**KNOXVILLE HISTORIC ZONING COMMISSION
STAFF REPORT - CERTIFICATE OF APPROPRIATENESS APPLICATION**

PROPERTY ADDRESS: 906 Luttrell St 37917
DISTRICT: Fourth and Gill H-1

FILE NO.: 5-E-14-HZ

APPLICANT: Open Door Architecture Sean Martin (architect)

west elevation (facing Luttrell St)

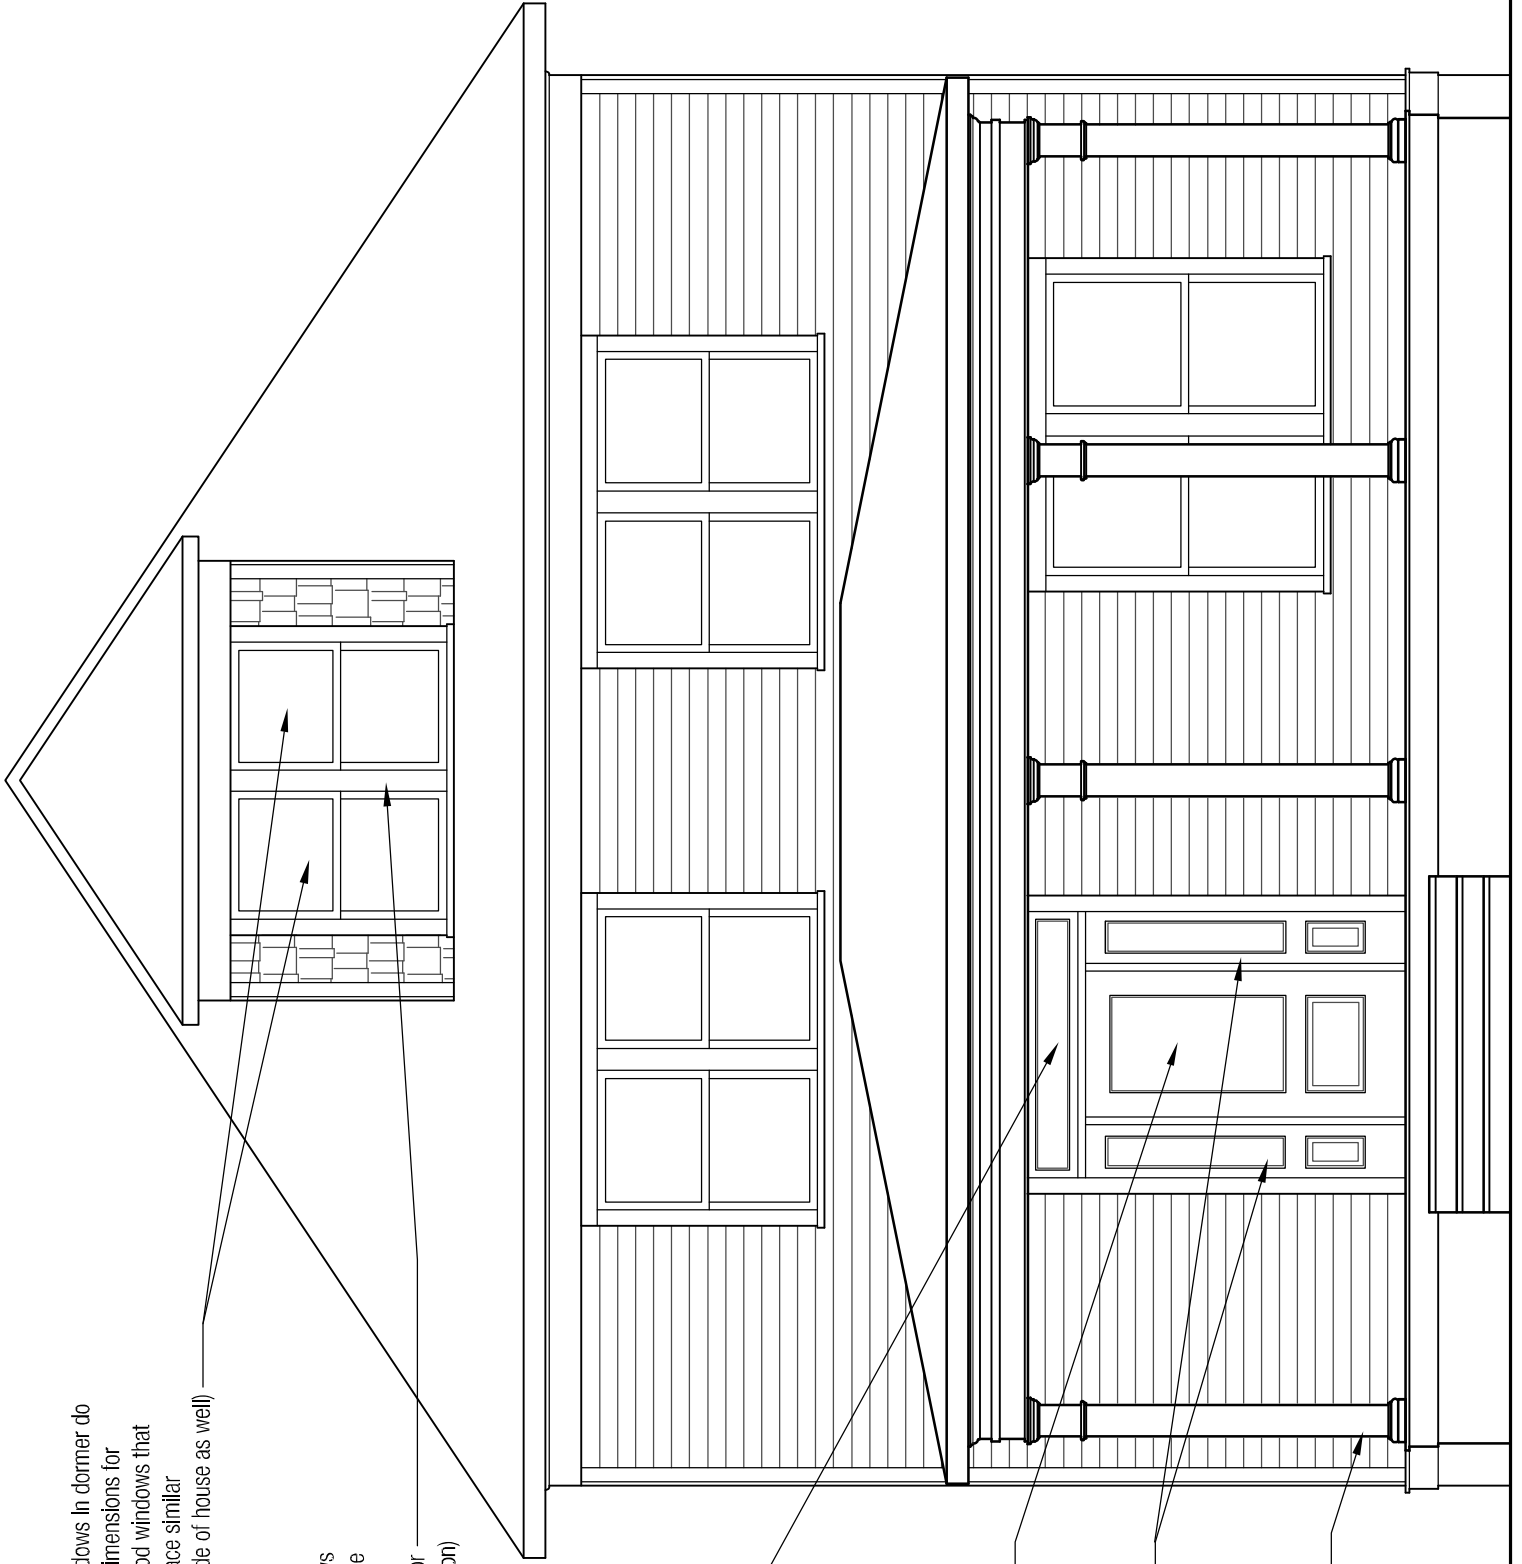
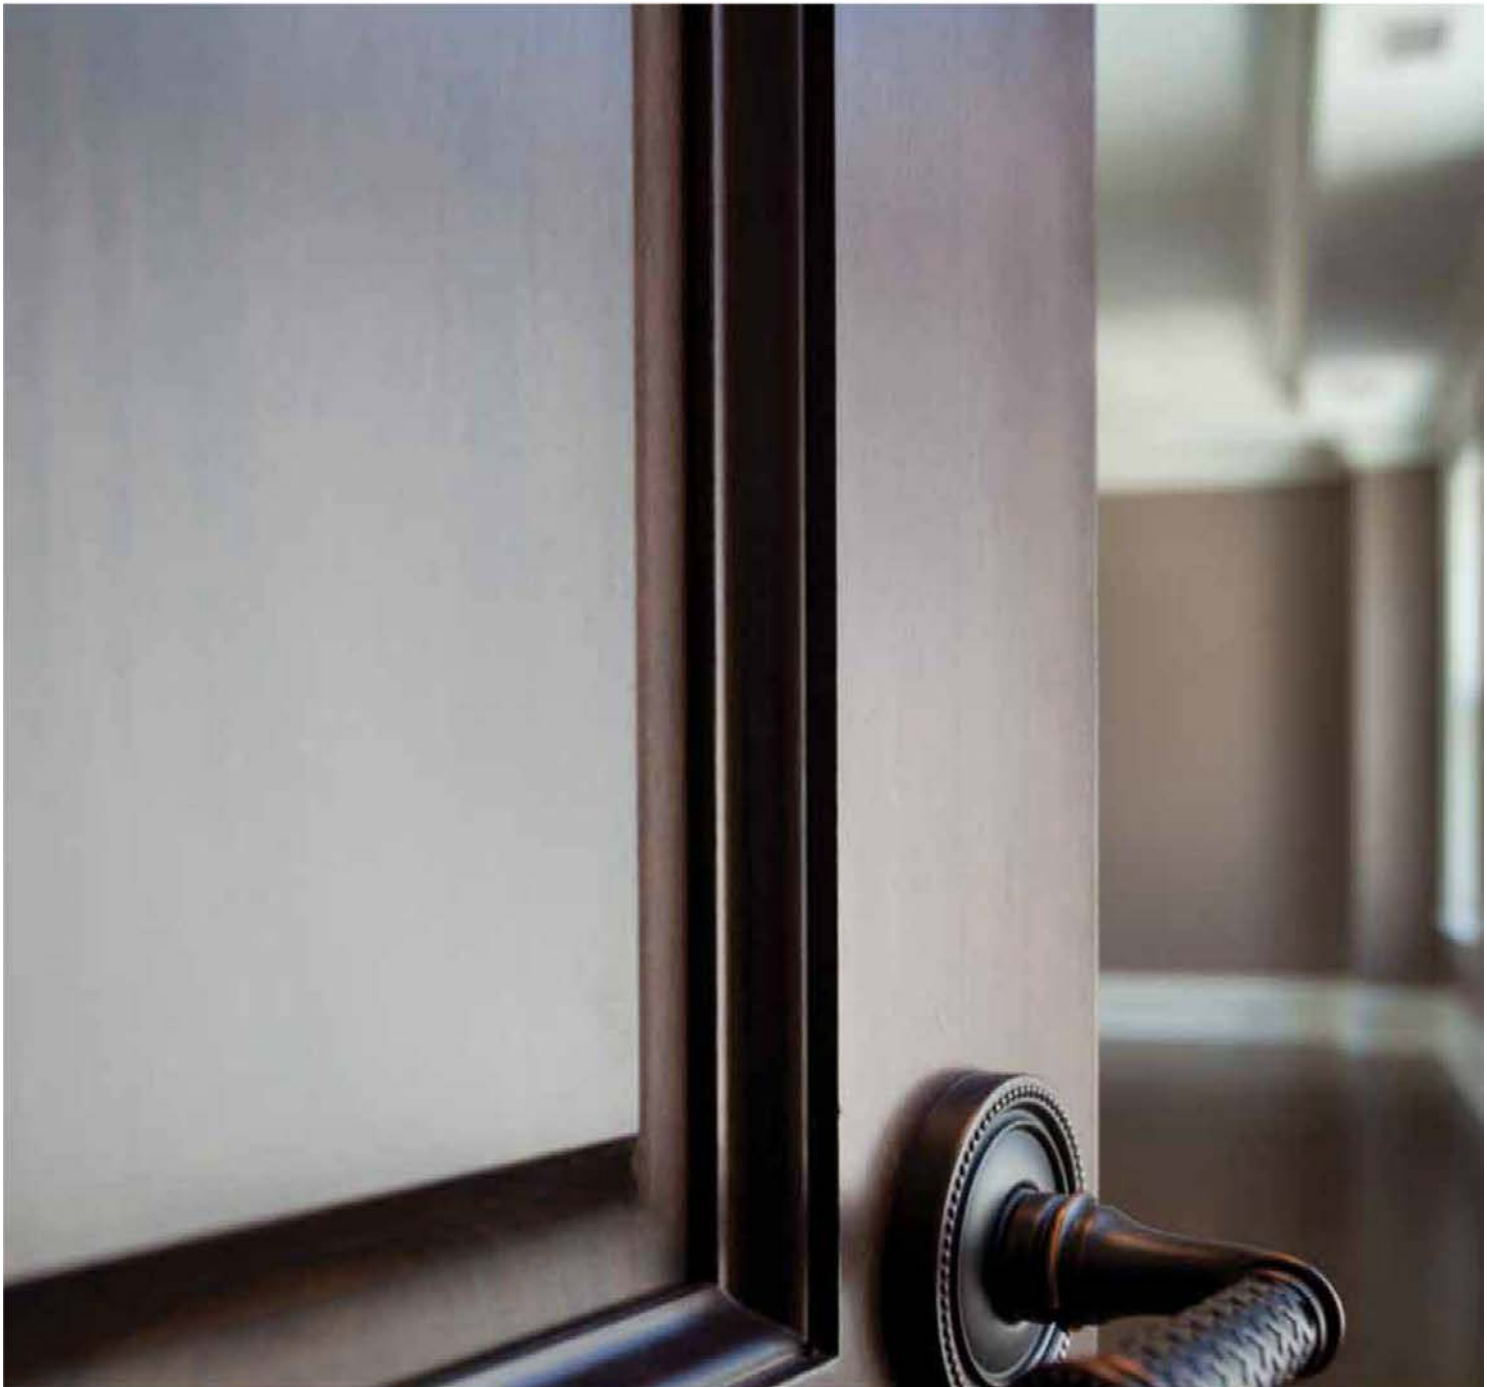
Existing replacement (non-original) windows in dormer do not comply with building code egress dimensions for openings. Replace with larger Pella wood windows that conform to egress requirements. (Replace similar windows in second dormer on south side of house as well)

Reduce wood trim between existing windows to accommodate new windows of greater width. Center trim will change from 12" wide to 5 1/2" wide to match original double windows on second floor (see attached photo for existing condition)

Replace wood & glass transom lost to fire with Koetter Woodworking transom #T01000 (see attached)

Replace wood front door lost to fire with salvage historic door to match original profile. If appropriate salvage door is unavailable, then replace with Koetter Woodworking 3/4 fire door #G01011 (see attached)

Replace wood & glass sidelights lost to fire with Koetter Woodworking sidelights #S01011 (see attached)

Replace all 4 fire-damaged existing non-riginal fiberglass porch columns (7" diameter) with new 8"x8" square porch posts. New posts to be fiberglass-reinforced polymer.

- 1) The front façade and the porch were destroyed by fire in April 2014.
- 2) Photo-documentation of the former porch and house façade exists.
- 3) The proposed in-kind replacement of elements with wood materials and like design meets the guideline recommendations.

Staff recommends approval of reconstruction of original façade and porch.
